HISTORIC AND DESIGN REVIEW COMMISSION

HDRC CASE NO: 2024-339
ADDRESS: 418 FLORIDA ST
319 E CAROLINA ST
LEGAL DESCRIPTION: NCB 3011 BLK 9 LOT 20
ZONING: C-2, H
CITY COUNCIL DIST.: 1
DISTRICT: Lavaca Historic District
APPLICANT: David Ranjbar/Prime & Paradigm Construction, LLC.
TYPE OF WORK: Construction of a commercial structure and fuel canopy; site work
APPLICATION RECEIVED: October 01, 2024
60-DAY REVIEW: November 30, 2024
CASE MANAGER: Edward Hall

The applicant is requesting conceptual approval to construct a commercial structure with a detached fuel canopy on the vacant lot addressed as 418 Florida and 319 E Carolina, located within the Lavaca Historic District.

ARCHITECTURAL
SITE PLAN

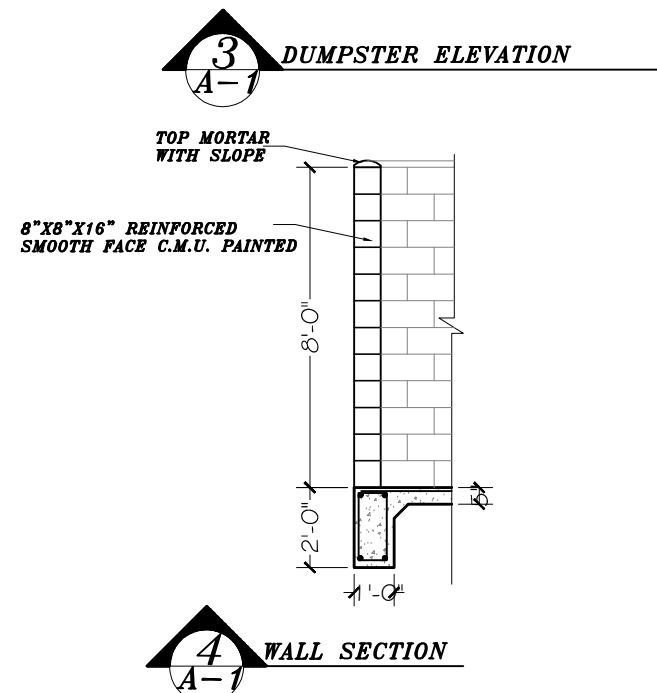
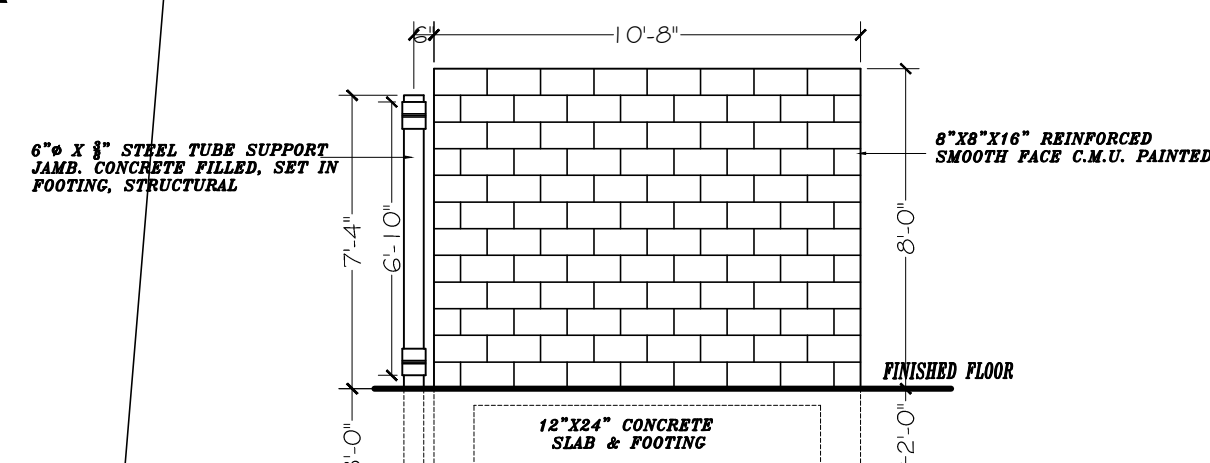
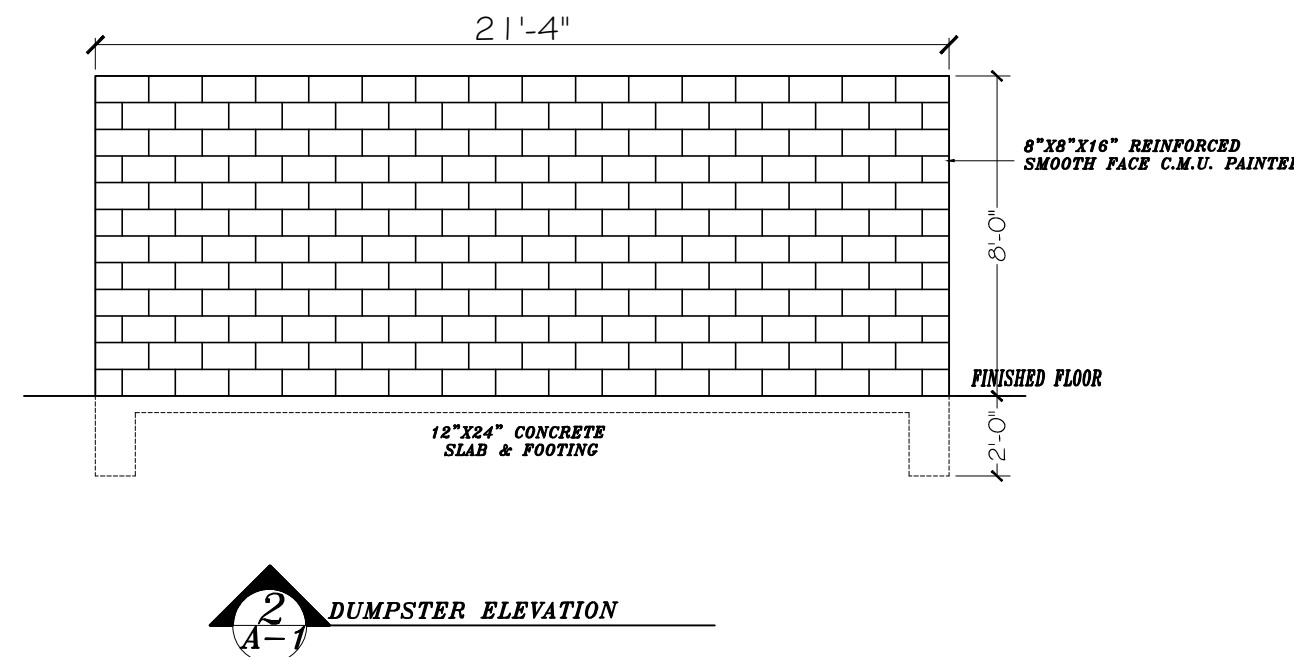
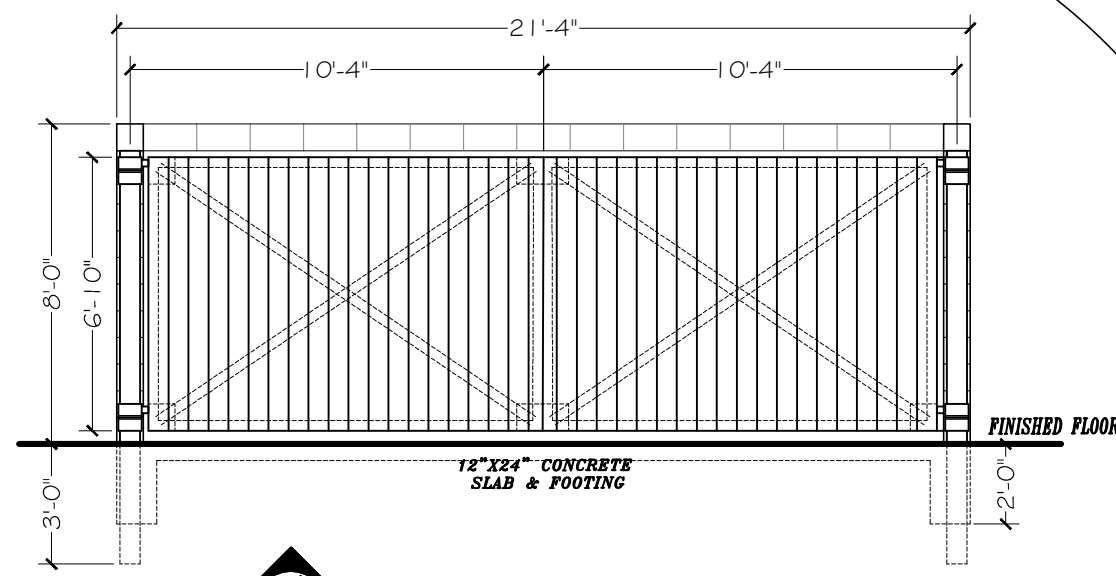
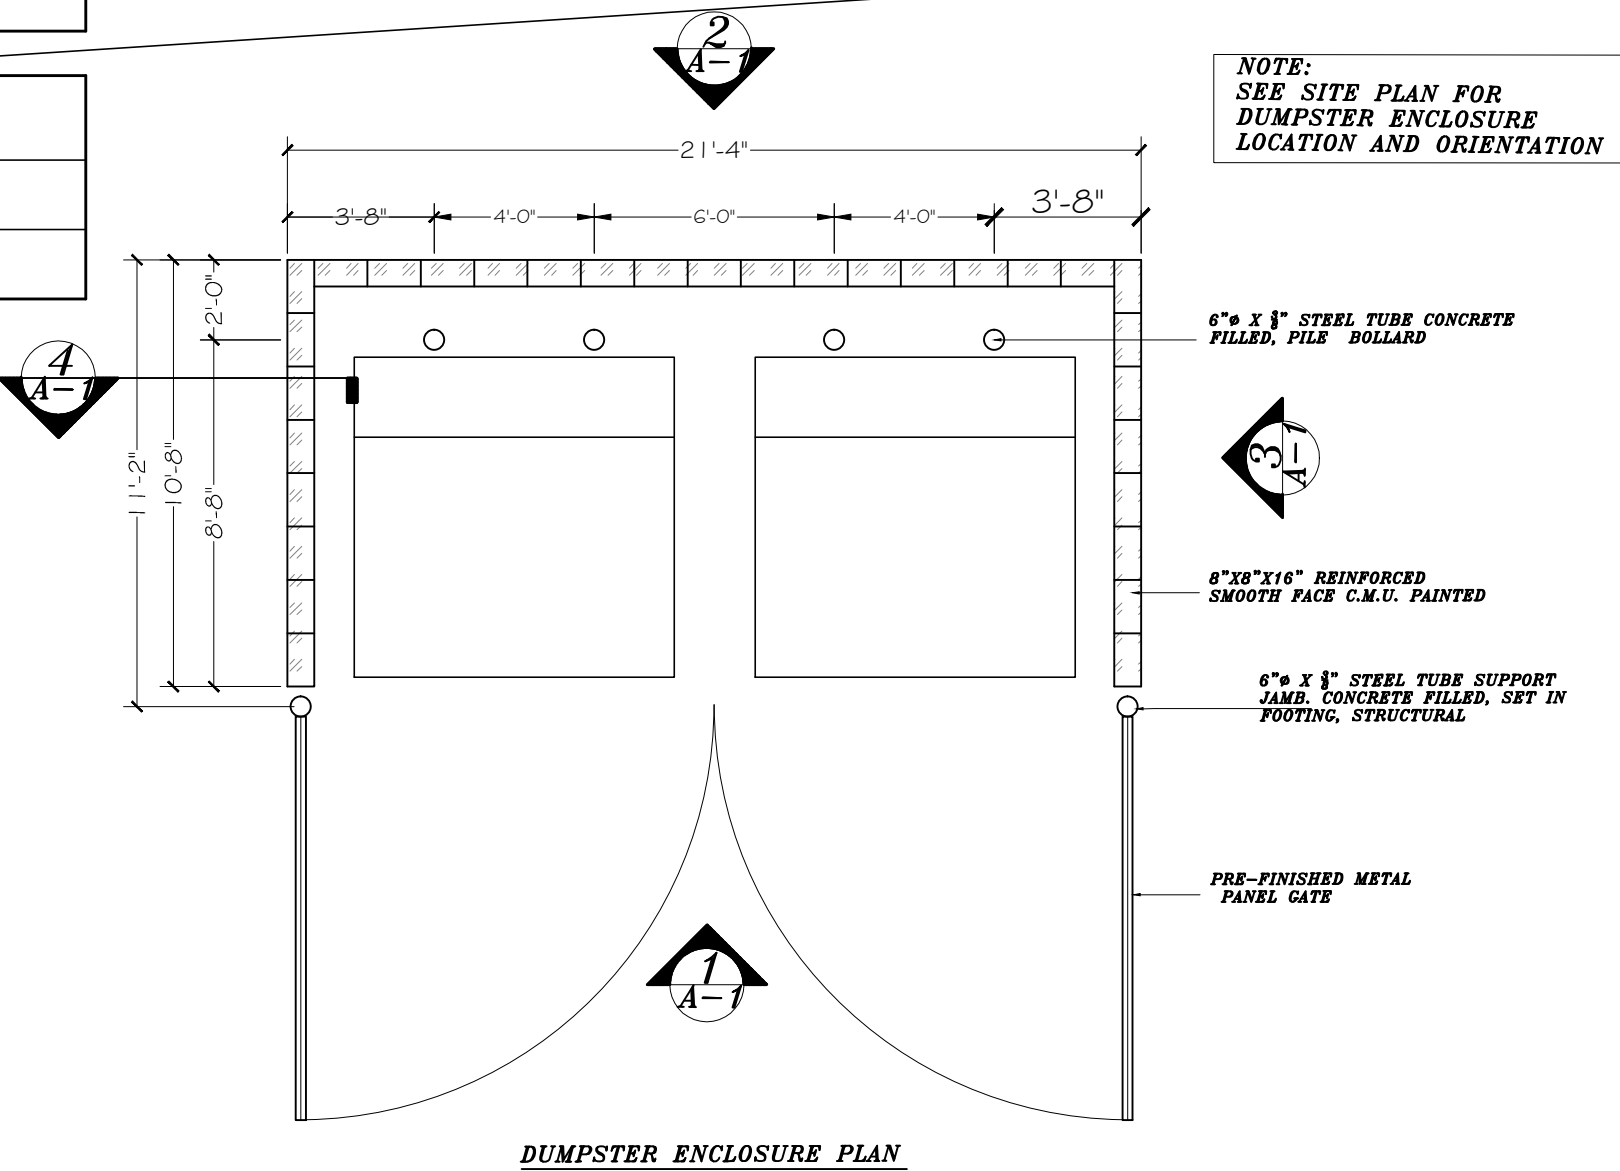
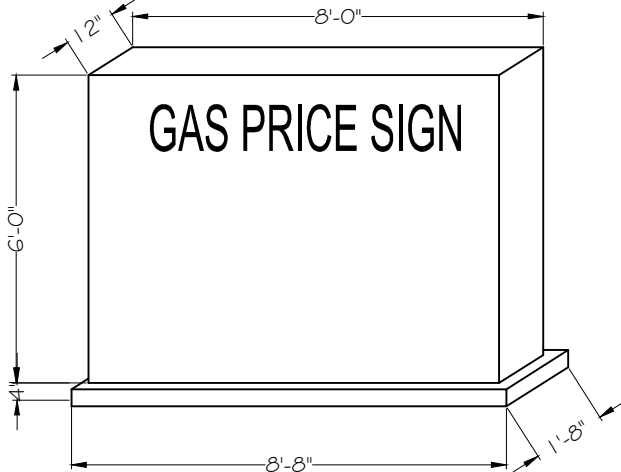
- r. DUMPSTER LOCATION – The applicant has proposed to install a dumpster in the southeast corner of the lot. The dumpster has been proposed to be located within a concrete masonry unit wall. Generally, staff is concerned regarding this location as it would be located directly in front of the historic structure at 318 E Carolina. Staff finds that the applicant should consider the relocation or repositioning of the dumpster, and that the applicant should apply stucco to the concrete masonry unit screening walls.

- s. VEHICULAR ACCESS – The applicant has proposed two vehicular access points into the site; one on E Carolina and one on Florida, which will feature individual entrance and exit lanes. The applicant has noted a curbcut width of twenty-five (25) feet on E Carolina; however, the applicant has not noted a total width of curb cuts on Florida. Generally, staff finds the proposed curb cuts to be appropriate; however, staff finds that no curb cut should exceed twenty-five (25) feet in width total.

- ix. That no curb cut exceed twenty-five (25) feet in width.
- x. That all setbacks as required by Zoning within the Unified Development Code are to be met. This includes a minimum 15-foot buffer yard along the west property line between the building and the residential properties.

- vii. That all mechanical and service equipment be located in a manner than screens it from view from the public right of way, as noted in finding p.
- viii. That the applicant consider the relocation or repositioning of the dumpster, and that the applicant apply stucco to the concrete masonry unit screening walls, as noted in finding q.
